APPENDIX D

COORDINATION DOCUMENTATION

**Re: Modifications to the Interim Operations and Exceptional Drought
Operations Plans**

Description of Proposed Action
Modification to the Interim Operations Plan at Jim Woodruff Dam

Jim Woodruff Outflow Based on Basin Inflow March-May; Spawning Period; Revised Down

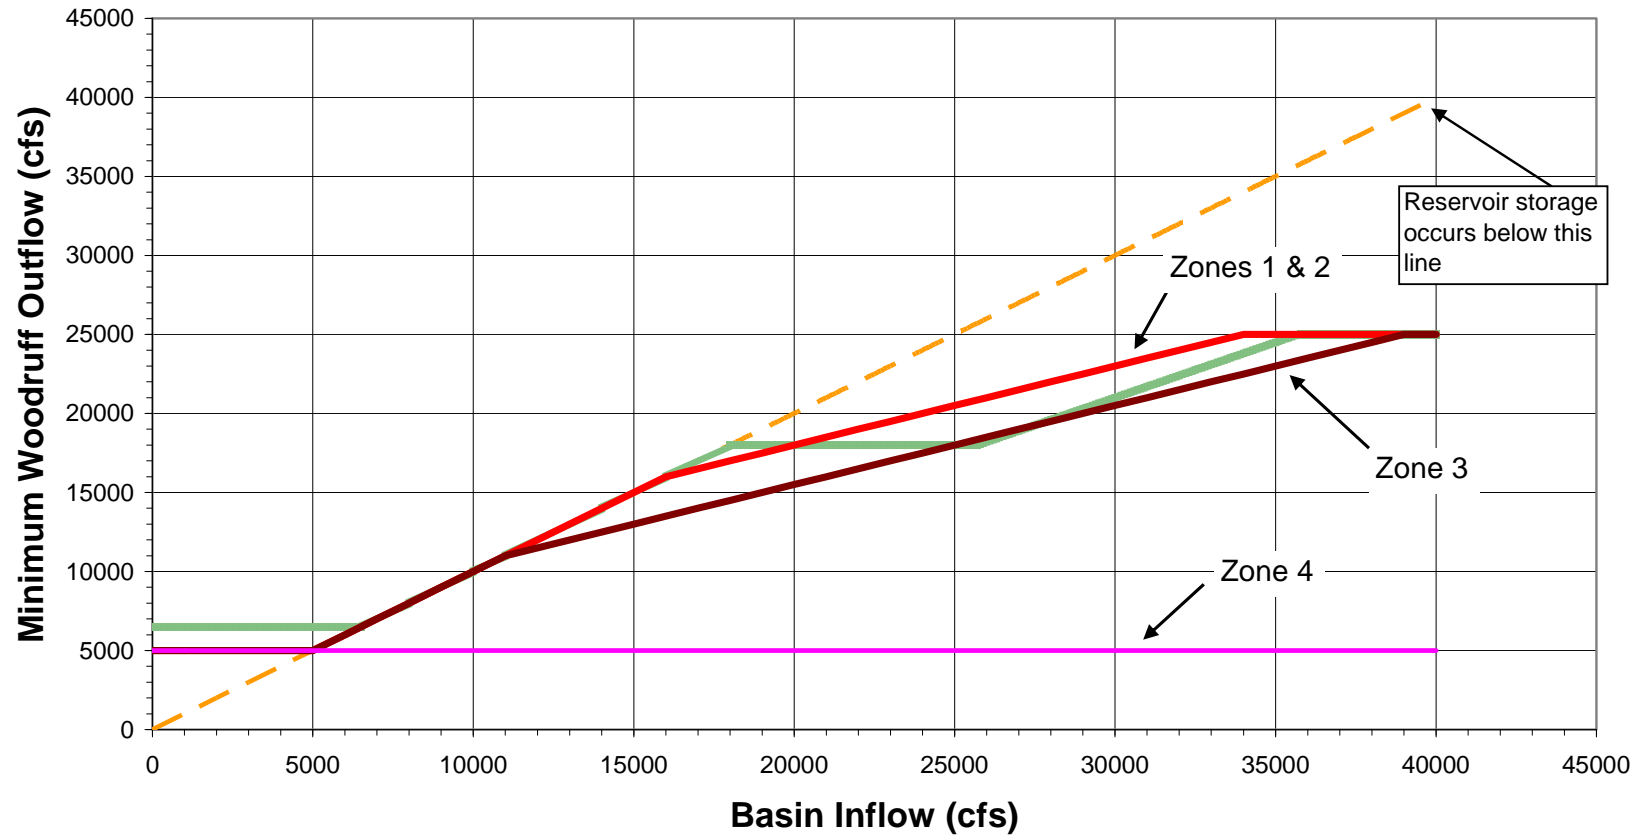
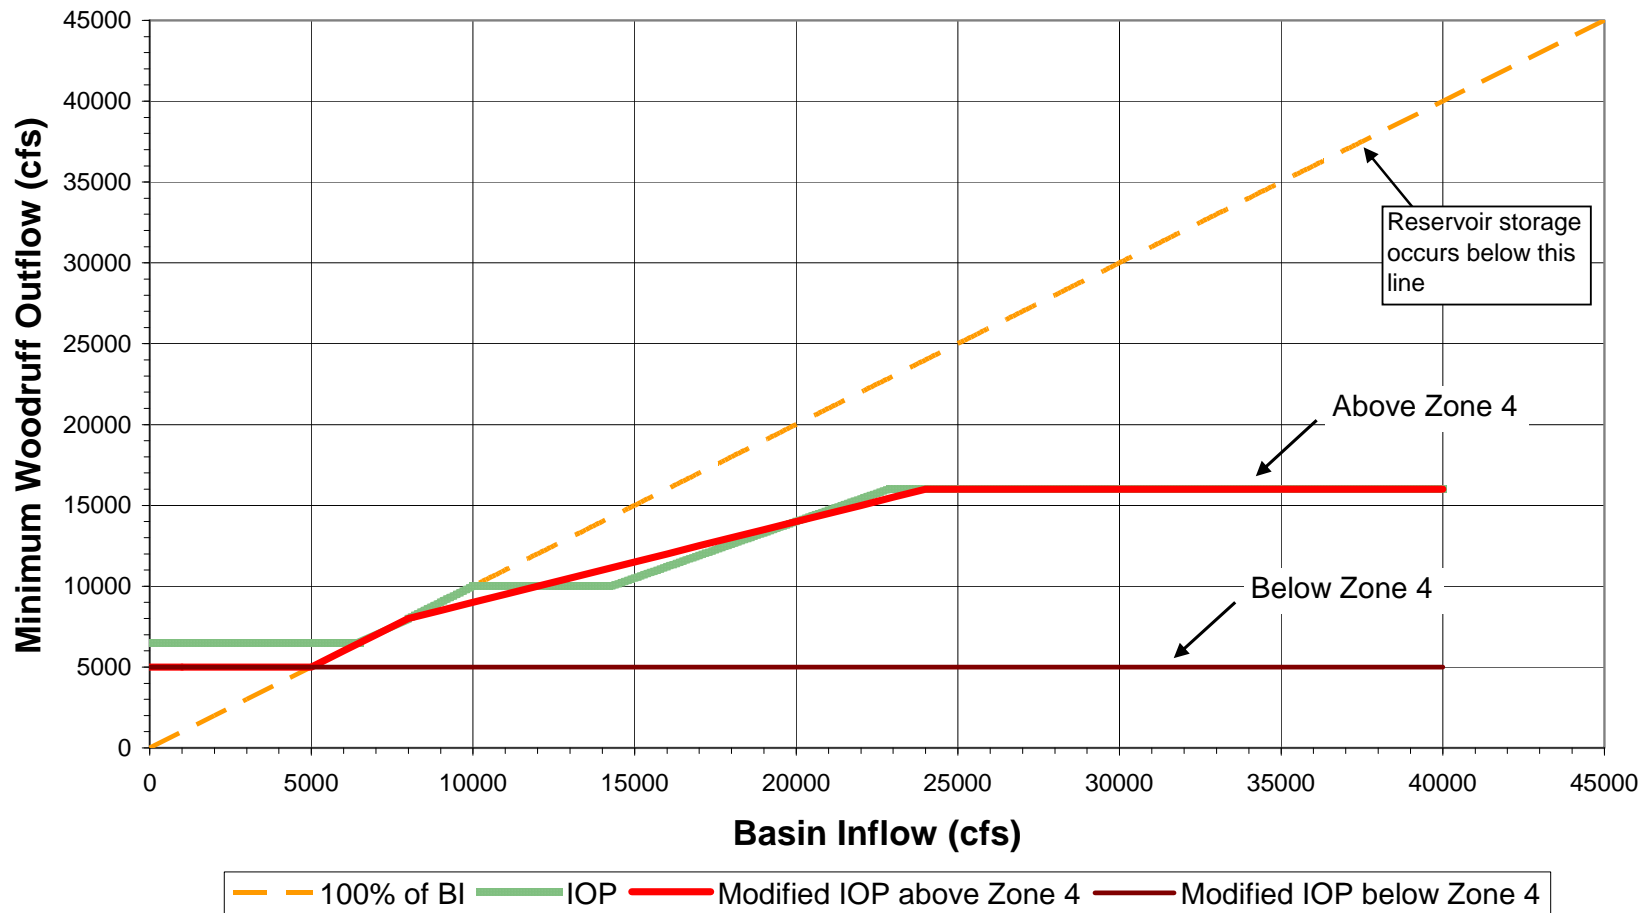
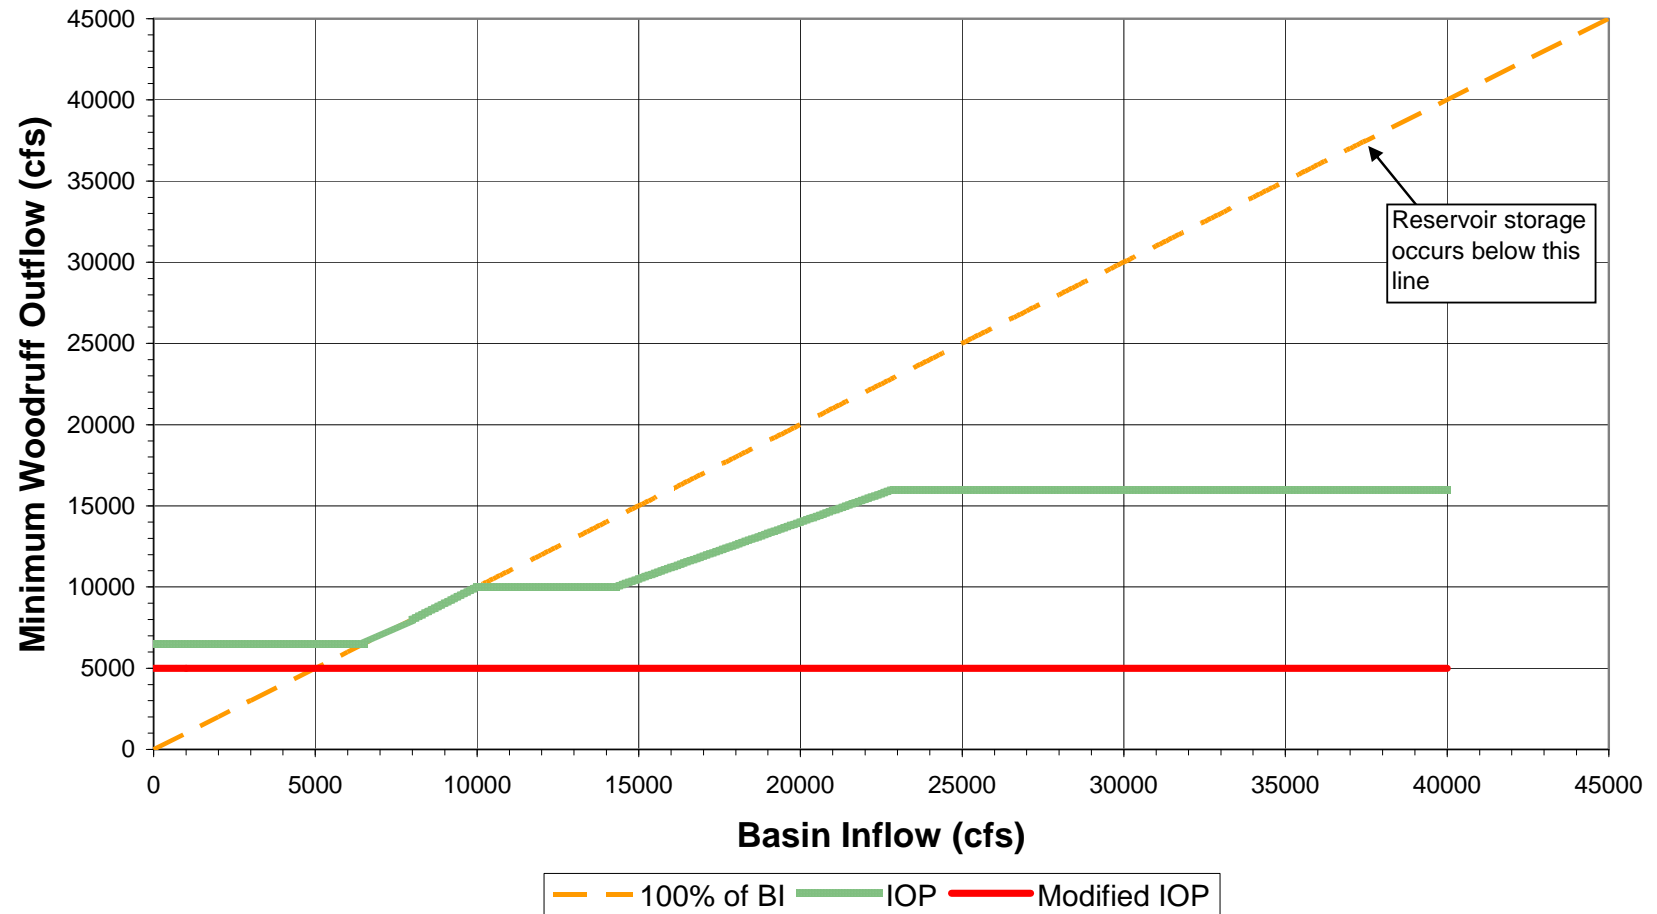
The figures below provide a graphical comparison of the operational provisions of the current IOP and the proposed action.

Fig. 2 Natural stage decline at Chattahoochee, Florida in comparison to the arbitrary ramping rates in the MIOP (Flow between 20000 and 30000 cfs)

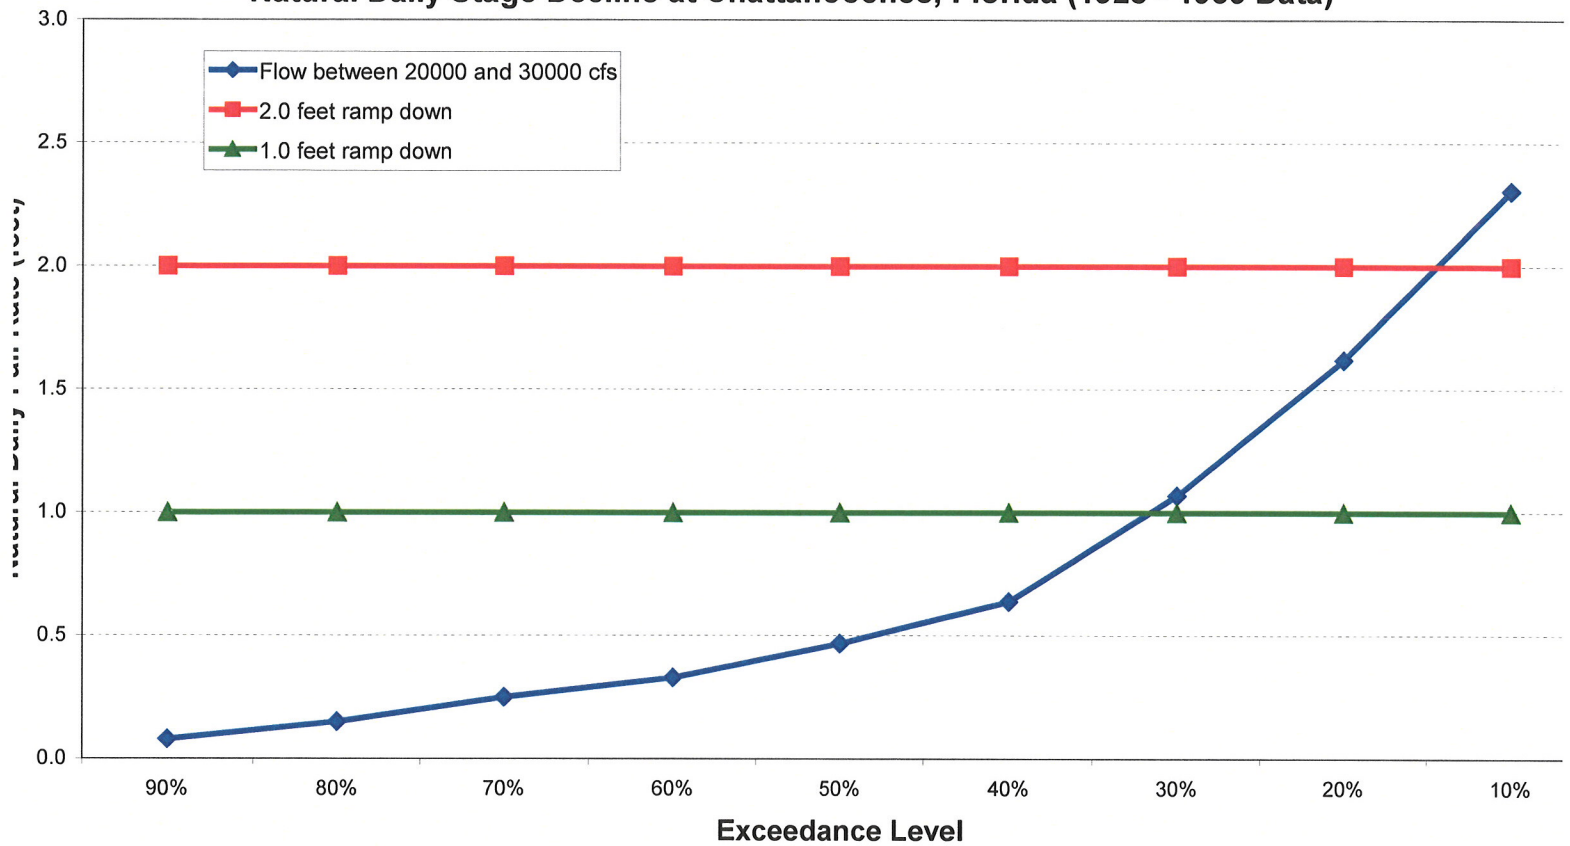
Due to constraints such as the ramp-down restrictions discussed above, operational imprecision, and head-difference limitations, the Corps has, as a practical matter, been unable to make releases from Jim Woodruff Dam in the same manner as what is called for under prior versions of the IOP. Typically, the Corps releases more water than is necessary to ensure that all flow targets are met. As an example, Figure 6 shows that, throughout the summer and fall of 2007, when the flow target remained at 5,000 cfs, the Corps maintained a minimum flow of greater than 5,100 cfs during this period. Even under EDO operations, when the flow requirement was 4,750 cfs, the Corps had to make releases of around 5,000 cfs due to head difference limitations. In addition to resulting in unanticipated losses of water, these over-releases of water are wholly or largely unaccounted for in the Corps modeling of the IOP and therefore undermine the effectiveness of the models as predictive tools.

Fig. 7 Hydrologic conditions in years 1993 and 2007

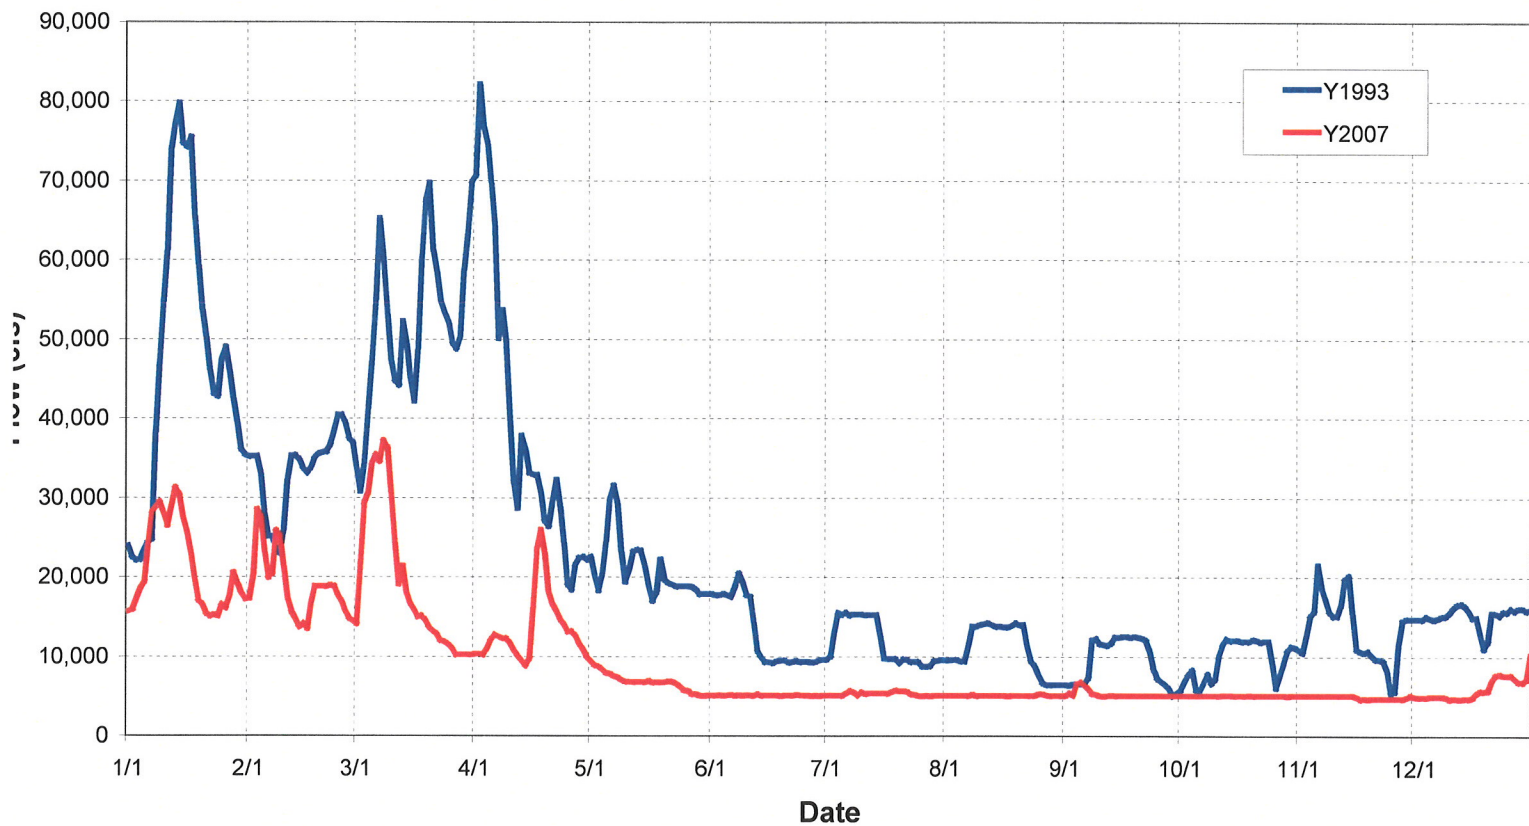
Furthermore, as shown in the Figure 7, weather conditions in 1993 were much wetter than conditions experienced in 2007. Even given the relatively abundant flows experienced in 1993, these higher flows were not able to prevent salinity in the Bay from reaching above 30 ppt. (See Huang, pp. 52-57). The difference in fresh-water input to the Apalachicola Bay between 1993 and 2007 (June through November period) equates to approximately 2.25 million acre-feet. The entire amount of conservation storage in the ACF Basin is only 1.64 million acre-feet. Even if the Corps had emptied the entire available storage from the ACF system in 2007, the fresh-water input would not have matched that of 1993 and would have been a futile attempt at lowering the salinity several miles out into the Bay.

Figure 1. Conservation Storage and Drainage Basin for ACF Reservoirs.

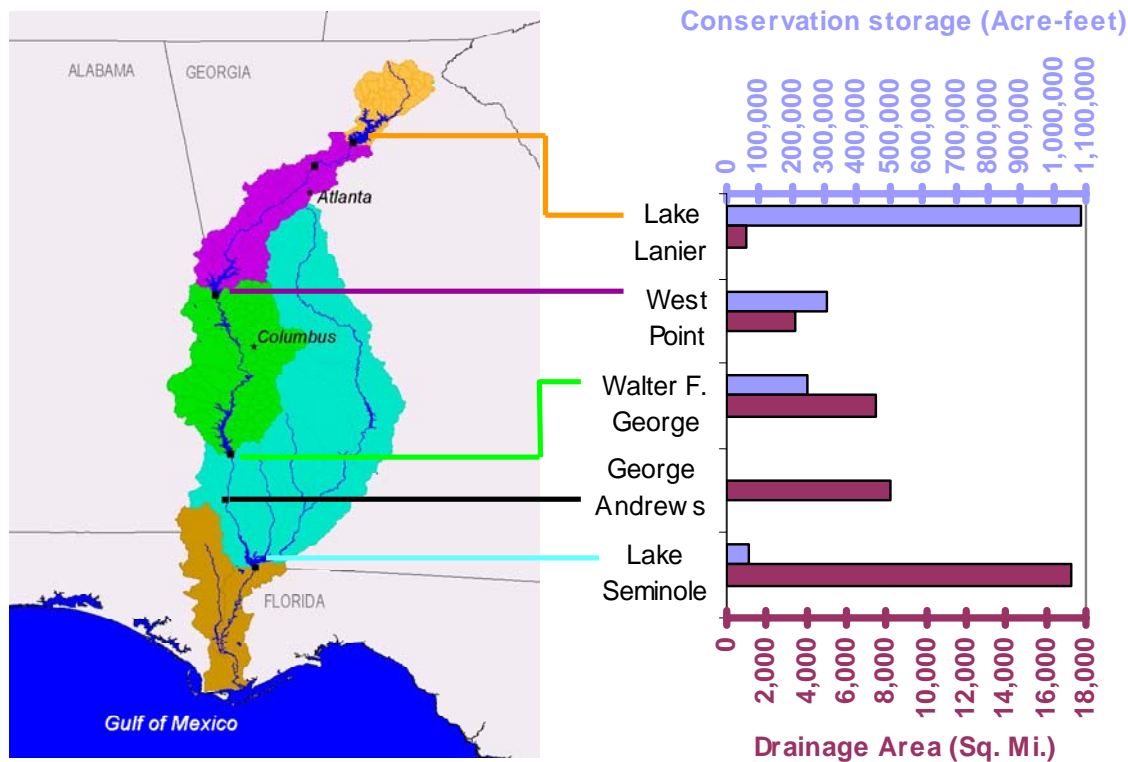
The reality is that only a small fraction of Basin Inflow can actually be captured in storage, regardless of what the MIOP might allow. The fraction of Basin Inflow that can be stored depends on the distribution of inflow in relation to storage. Of the 17,230 mi.² drainage basin above Lake Seminole, 95% is below Lake Lanier, which represents 65% of total system storage; 80% is below West Point, which, together with Lake Lanier, represents 85% of total system storage; and 57% is below Walter F. George, which is the last storage project in the system. *See Figure 1.* In other words, run-off from 57% of the basin cannot be captured in any reservoir and 80% of the basin is controlled by the smallest storage project in the system, with only 244,000 acre-feet.

Figure 5. Flow at the Chattahoochee gage under MIOP as compared to flow under the “At Site Objectives” Operating plan.

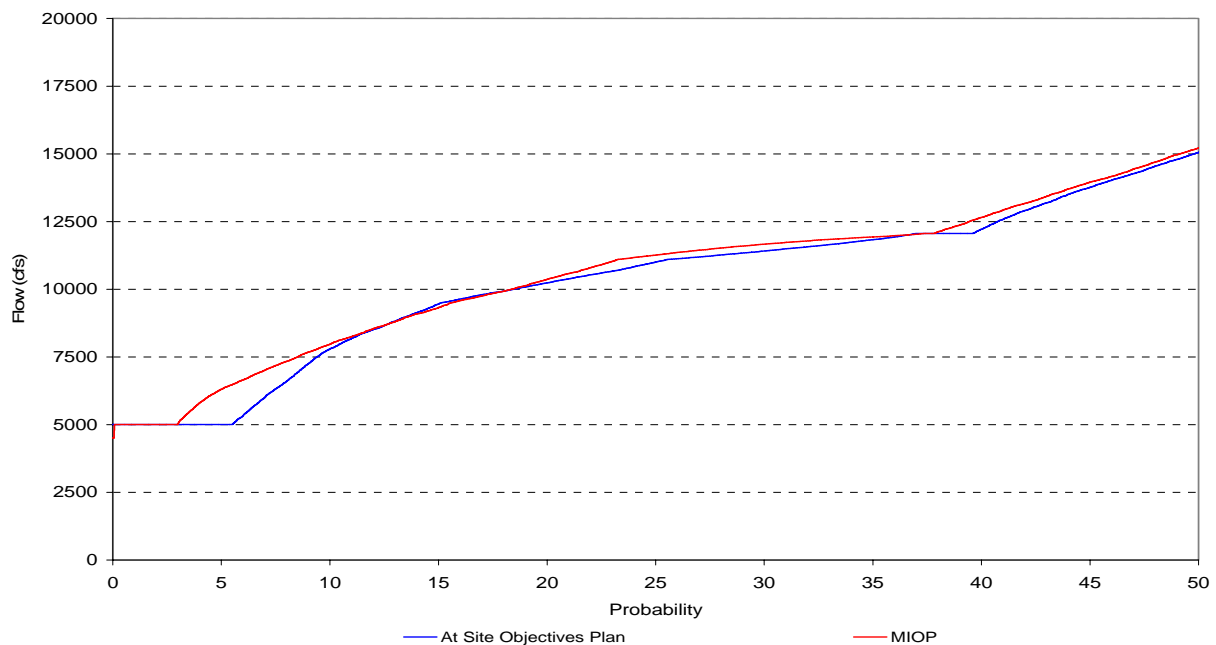
Figure 5 and Figure 6 show the cumulative distribution of flows at the Chattahoochee gage for the MIOP and the “At Site Objectives” Plan. Although the MIOP does provide slightly higher flows in the range between 5,000 cfs and 15,000 cfs, *see* Figure 5, the difference is remarkably small and insignificant over the entire range of flows. *See* Figure 6.

Figure 6. Flow at the Chattahoochee gage under MIOP as compared to flow under the “At Site Objectives” Operating plan.

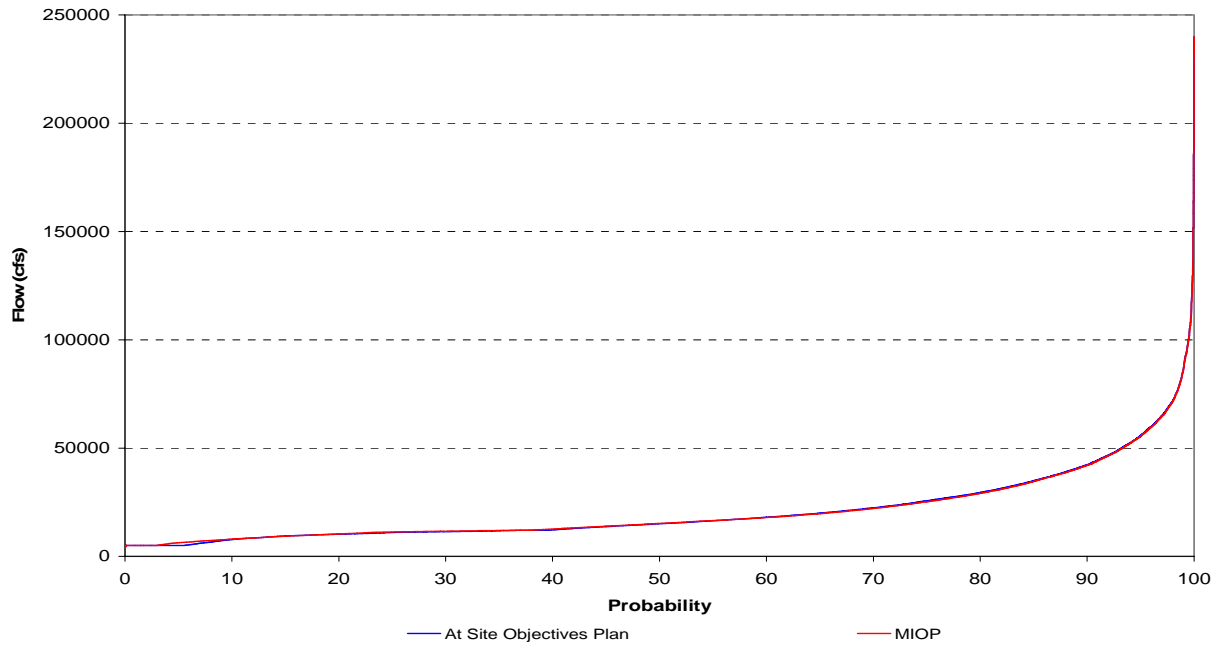
The differences between the MIOP and the At Site Objectives Plan are even less significant when one considers impacts to the hydrograph. Figure 7 through Figure 9 show three representative two-year periods, two dry and one wet. These figures demonstrate that reservoir operations have little effect on the overall timing and pattern of flows in the Apalachicola River.

Figure 14. Apalachicola River stage at Chattahoochee gage from April 28, 2008 to May 29, 2008.

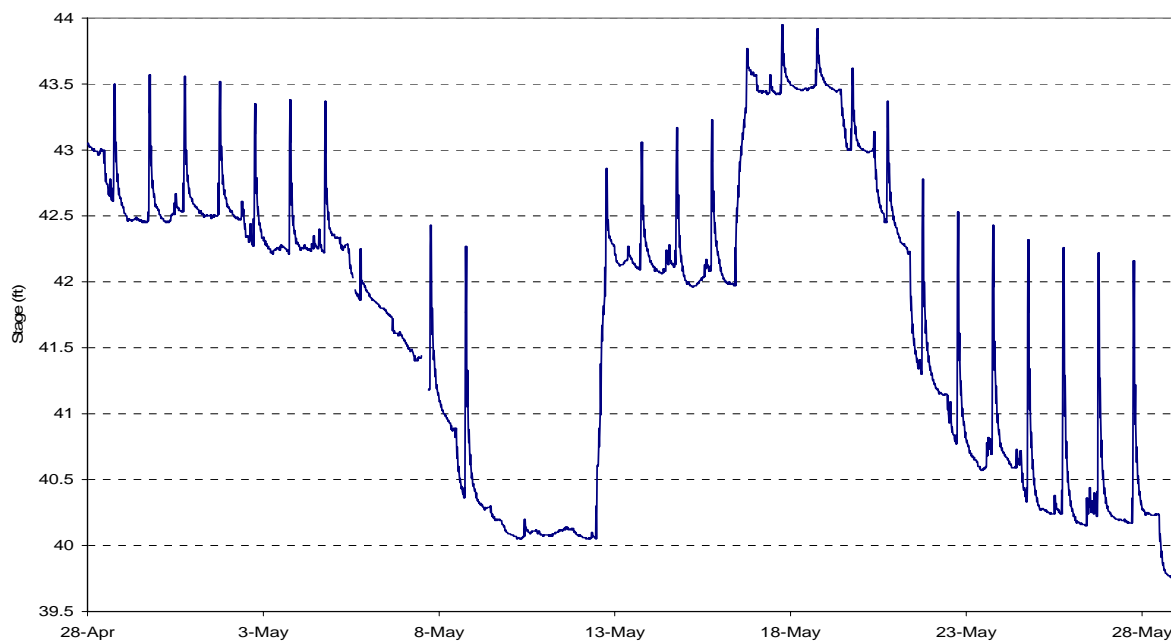
To put this in perspective, metropolitan Atlanta's average consumptive use of 250 cfs corresponds to approximately 1.8 inches in river stage at the Chattahoochee gage in the Apalachicola River at the river's lowest flow. This in a river that fluctuates wildly, often as much as 2 feet per day as a result of hydropower operations. *See Figure 14.*
